Addendum No. 1

RE: Contract # C204471
WBS # 45446.3.1
FEDERAL-AID NO. NHS-0421(072)
Wilkes County (U-5312)
US-421 FROM EAST OF NC-16 TO US-421 BUS.

The following revisions have been made to the Utility Construction Plans.

LOCATION: US 421 FROM NC 16 TO US 421 BUSINESS IN WILKESBORO
TYPE OF WORK: WATER AND SANITARY SEWER RELOCATION

PROJECT REFERENCE NO.	U-5312	SHEET NO.	UC-33
DESIGNED BY:	B. CLAWSON		
DRAWN BY:	R. MOSS		
CHECKED BY:	B. CLAWSON		
APPROVED BY:			
REVISED:	11/2/23		
MUNICIPAL ENGINEERING SERVICES COMPANY, PA.	P.O. BOX 97 GARNER, NC 27529 (919) 772-5393		
		UTILITY CONSTRUCTION PLANS ONLY

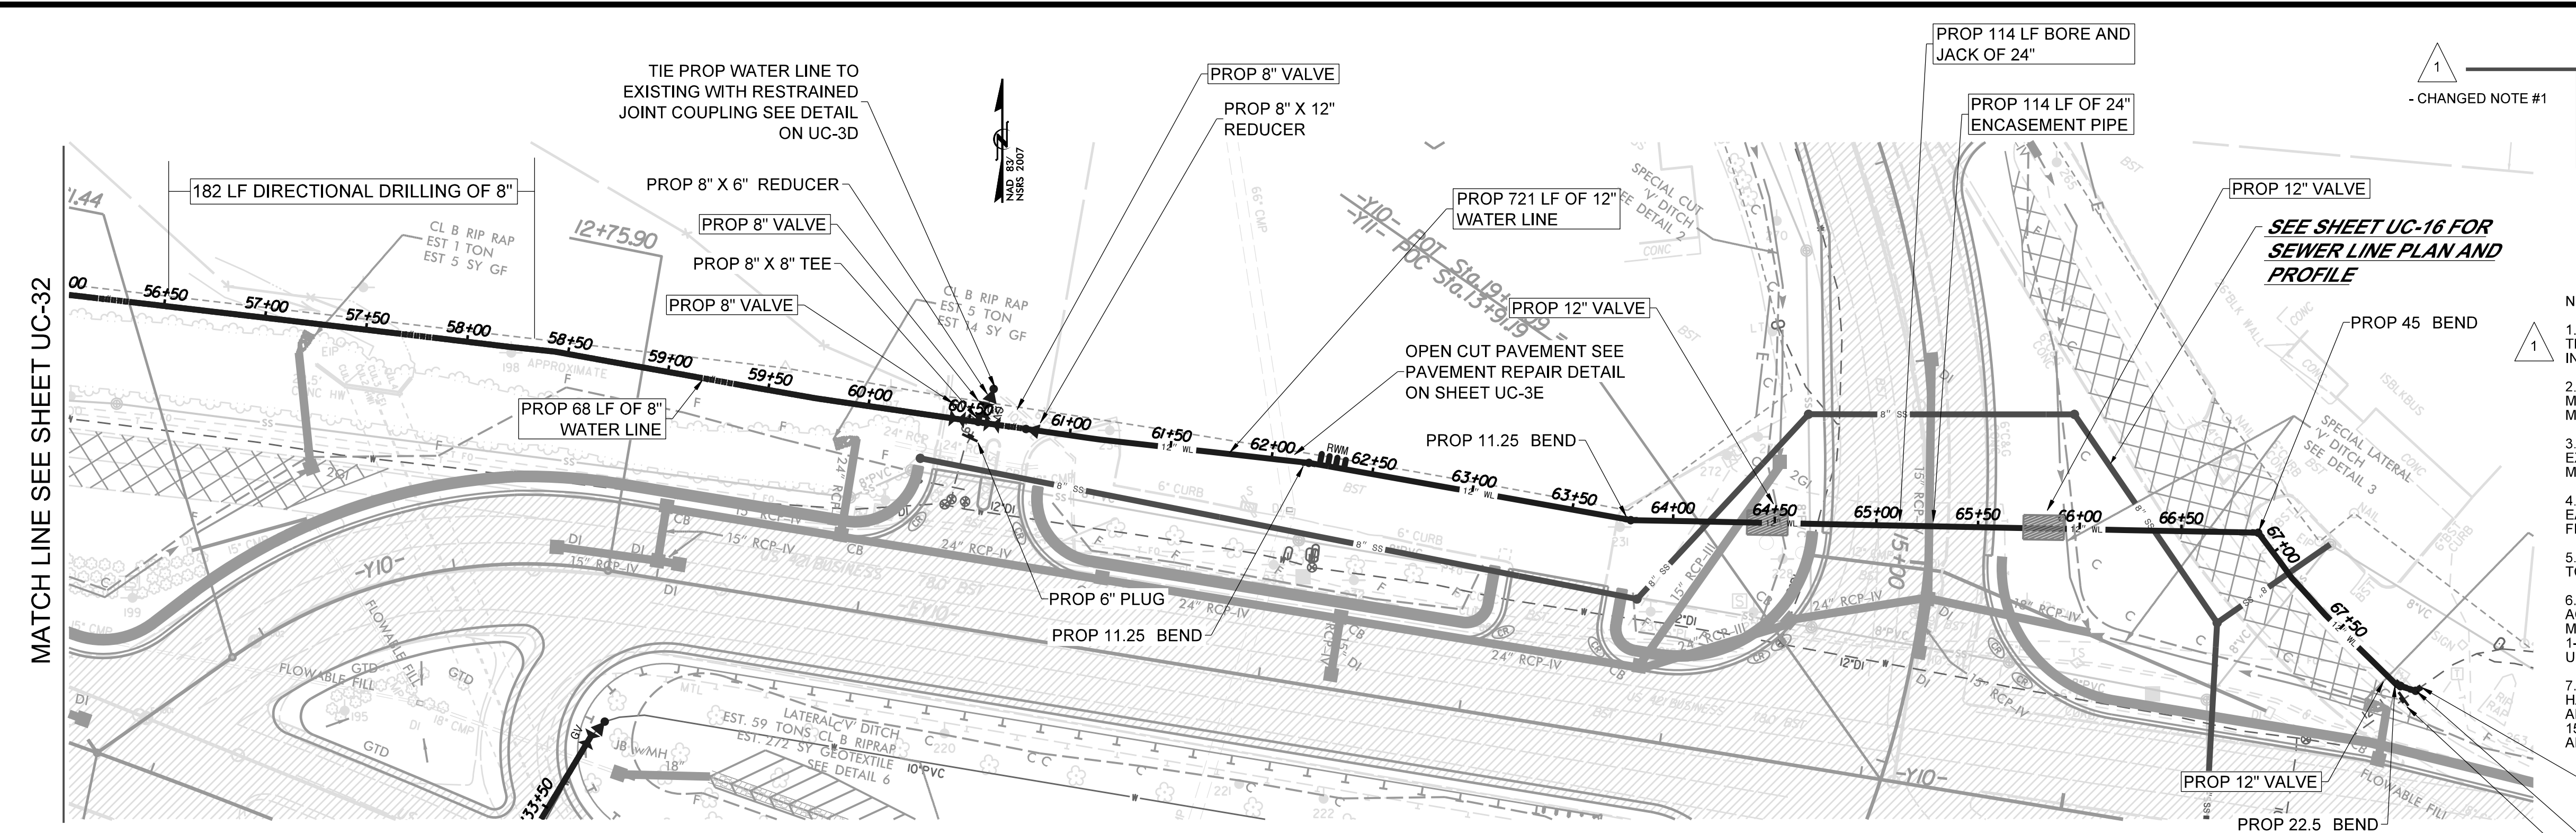
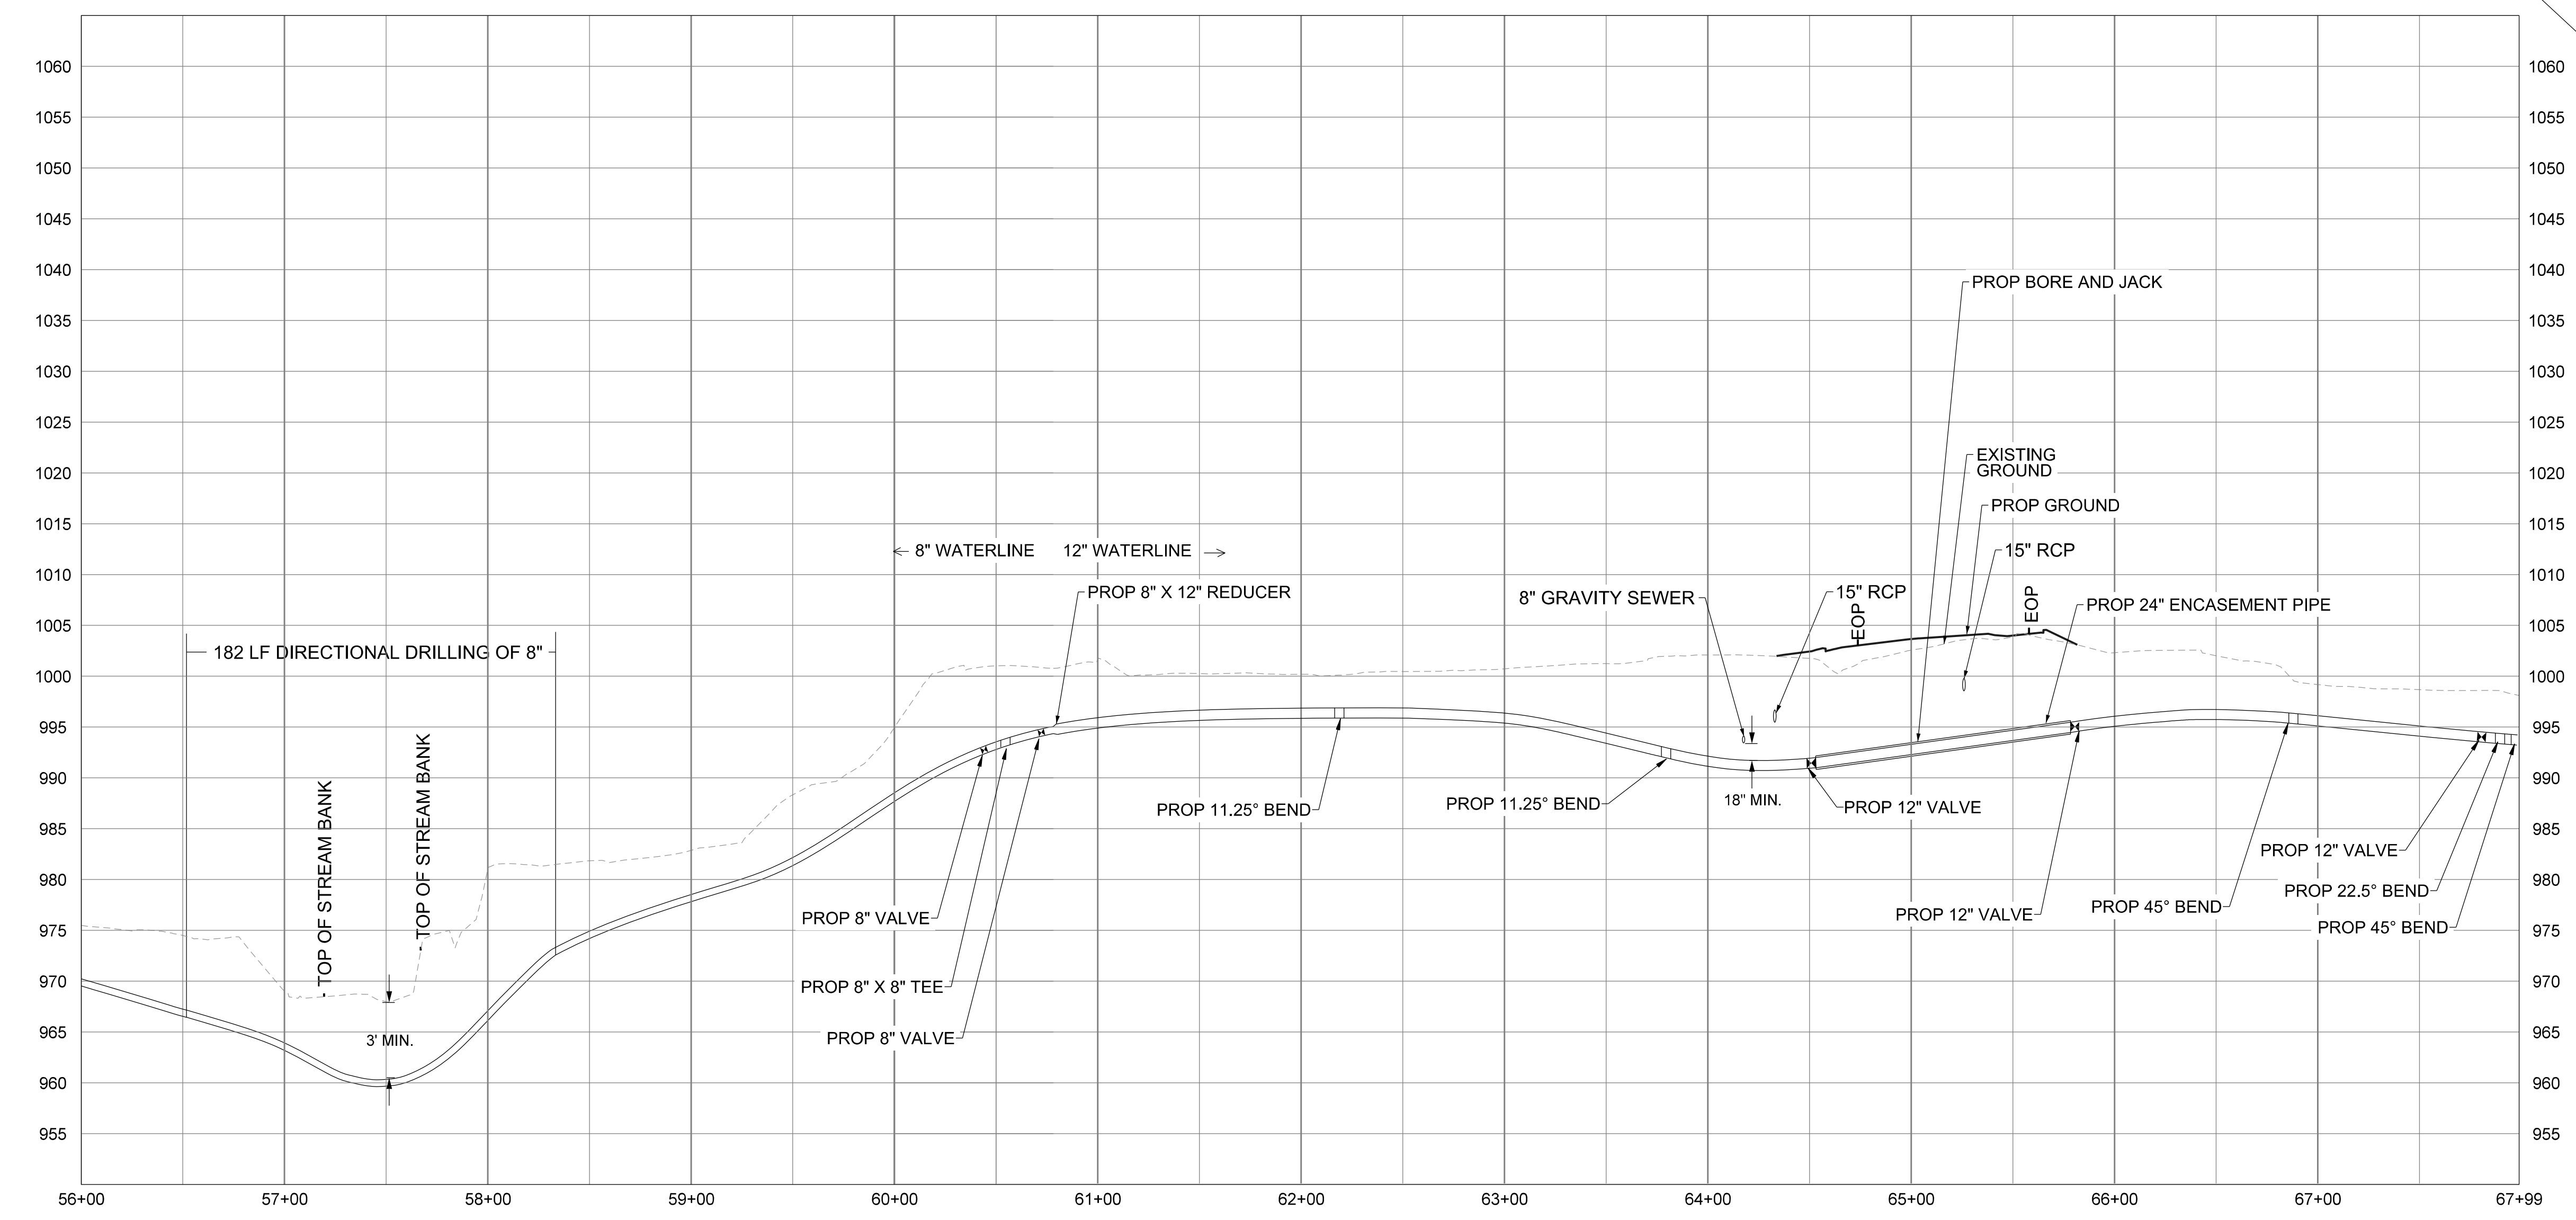
1
- CHANGED NOTE #1

- NOTES:
1. WATERLINE MATERIAL SHALL BE: DIP-CLASS 350 (ALL OPEN TRENCH INSTALLATIONS), HDPE -DR7 (DIRECTIONAL BORE INSTALLATIONS), COPPER (SERVICE INSTALLATIONS)
